May 8, 2002

LCV-1617

**VOGTLE ELECTRIC GENERATING PLANT
REQUEST TO REVISE TECHNICAL SPECIFICATIONS
REACTOR TRIP SYSTEM INSTRUMENTATION OVER TEMPERATURE DELTA
TEMPERATURE (OTAT) AND OVERPOWER DELTA TEMPERATURE (OPAT)
REACTOR TRIP FUNCTIONS**

Marked-up Pages	Note
Figure 2.1.1-1	1
Page 3.3.1-20	2
Page 3.3.1-21	2
Figure B2.1.1-1	1
Page B3.3.1-19	2
Page B3.3.1-21	1
Page B3.3.1-65	2

Figure 2.1.1-1
Reactor Core Safety Limits

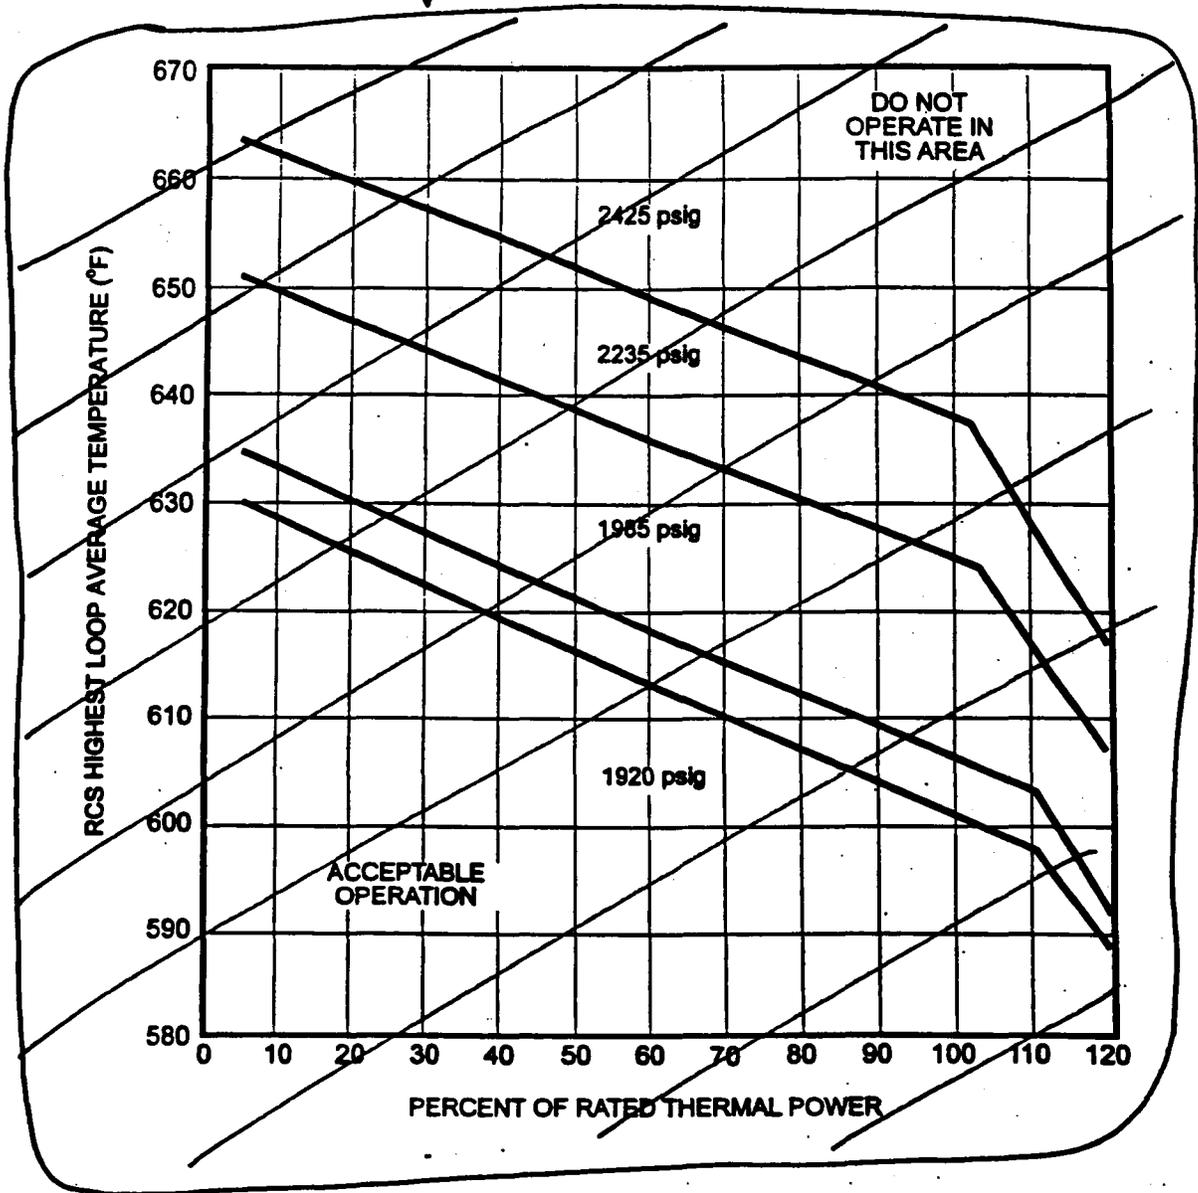
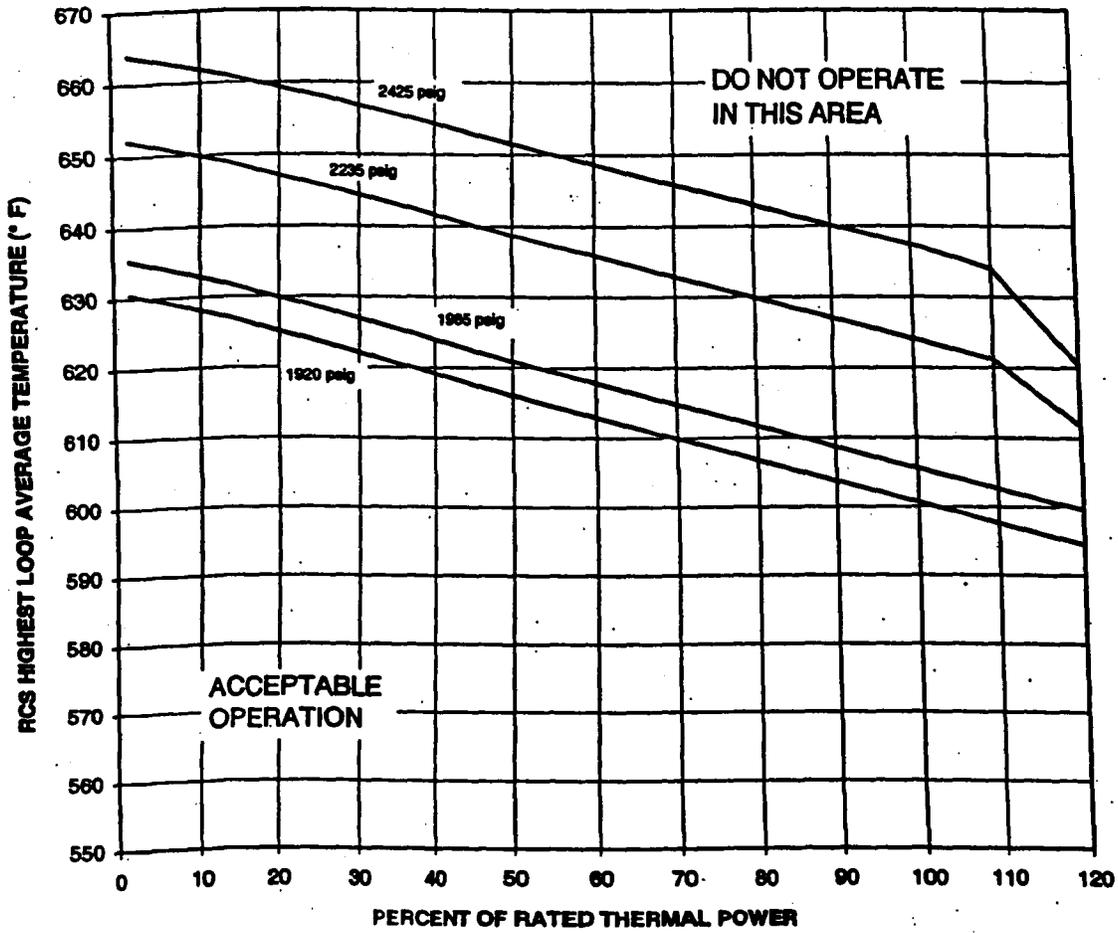
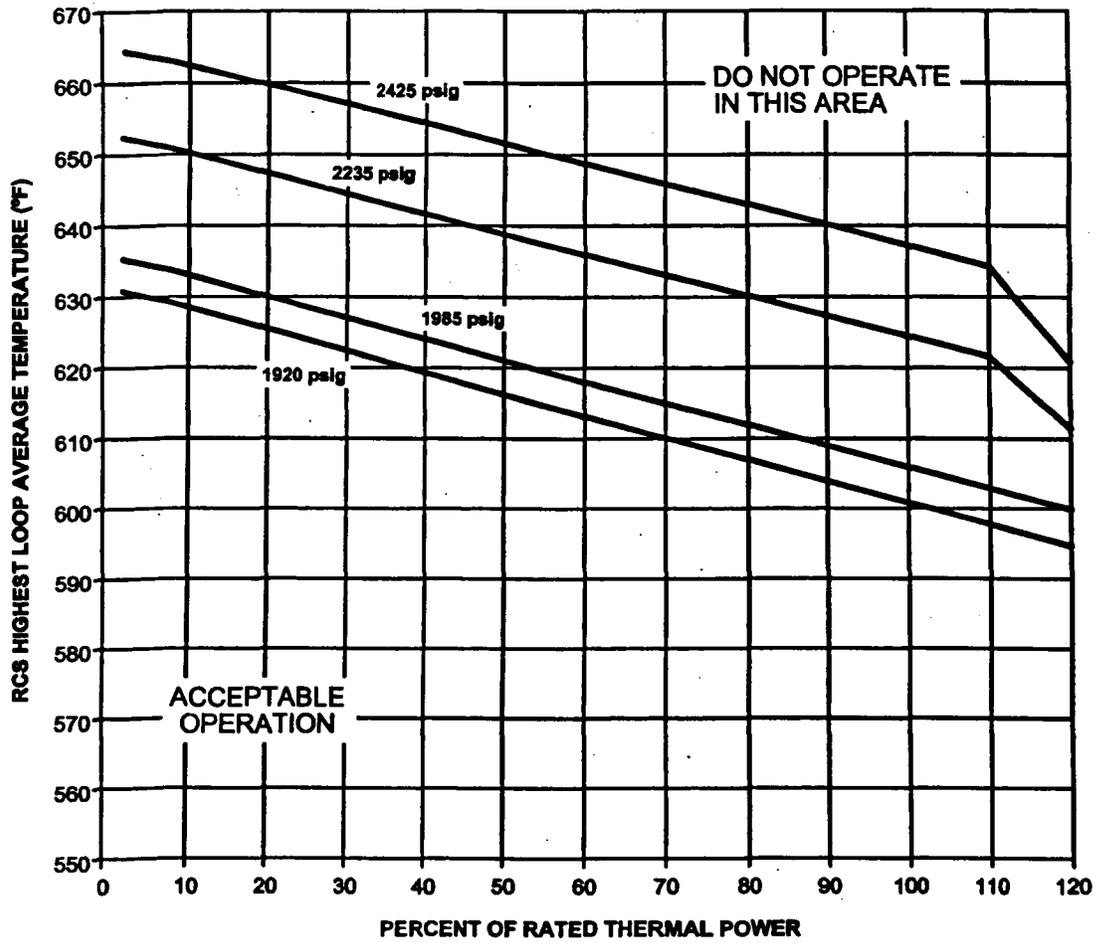
In accordance with the requirements of 10 CFR 50.90, Southern Nuclear Operating Company (SNC) proposes to revise Vogtle Electric Generating Plant (VEGP) Unit 1 and Unit 2 Technical Specifications (TS) Figure 2.1.1-1, "Reactor Core Safety Limits"; Table 3.3.1-1, "Reactor Trip System Instrumentation"; and the associated Bases B2.1.1 and B 3.3.1.

Revised core thermal limits were calculated for the VEGP MRP. The core limits are revised to account for a higher Minimum Measured Flow to be consistent with the current reactor coolant system flow measurement uncertainty, a decrease in the core bypass flow (assumes thimble plugs installed), the removal of the fuel transition core penalty (core limits are applicable to VANTAGE-5 and VANTAGE+ fuel), and an overpower limit increase from 118% to 120%.

INSERT A

Figure B 2.1.1-1 (page 1 of 1)
REACTOR CORE SAFETY LIMITS VS. BOUNDARY OF PROTECTION

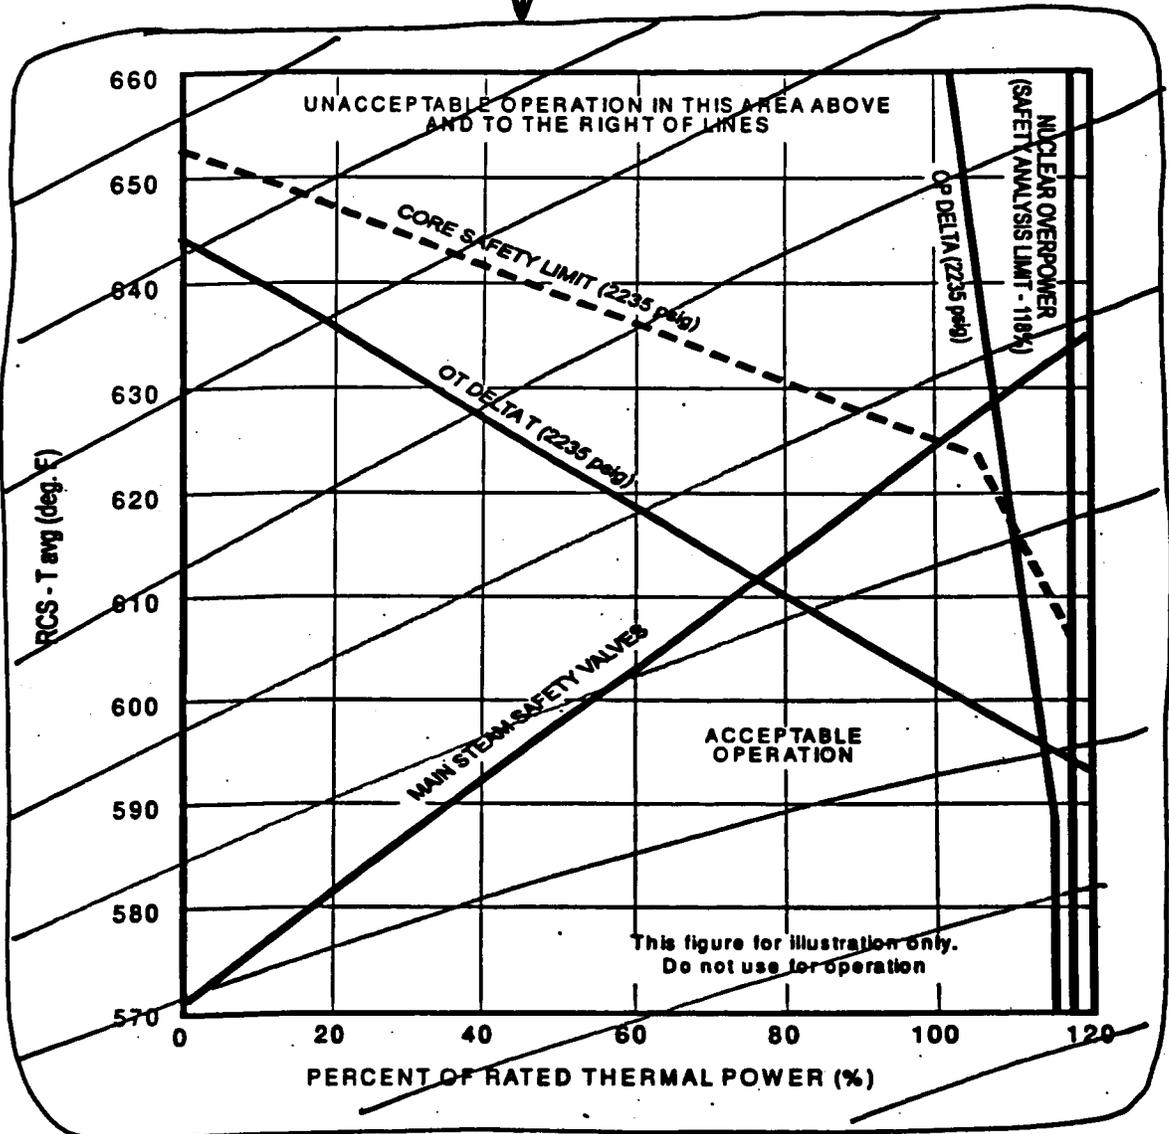
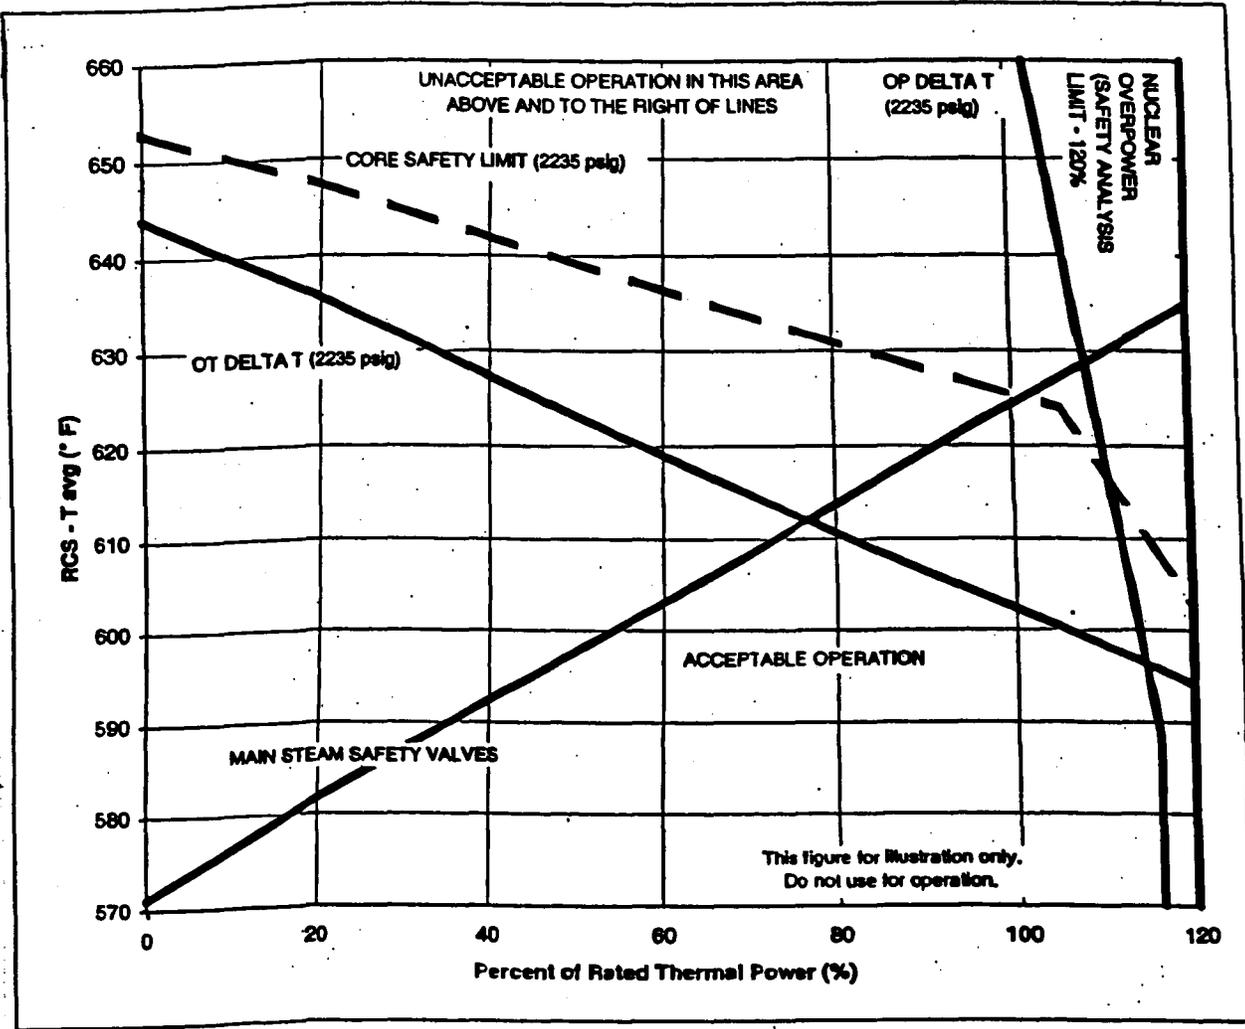
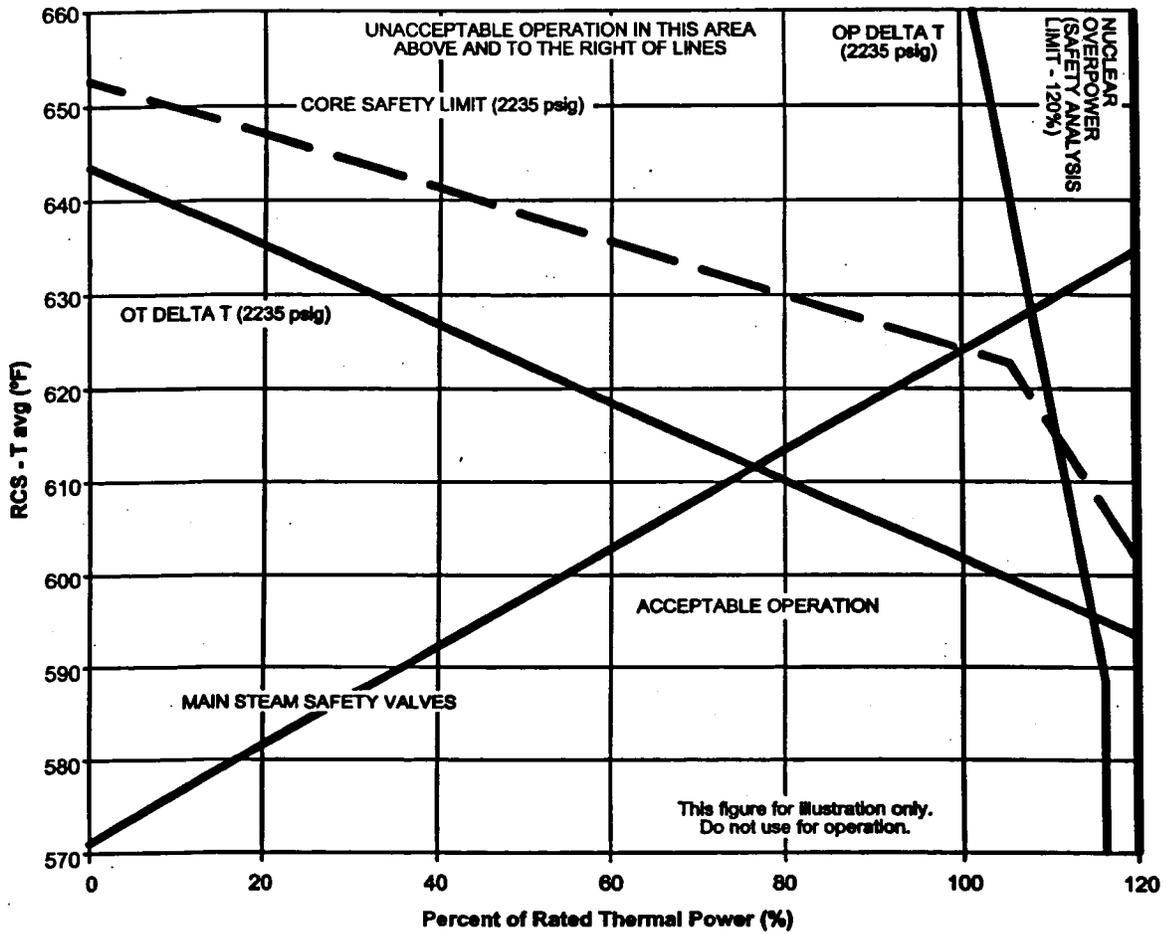
INSERT B
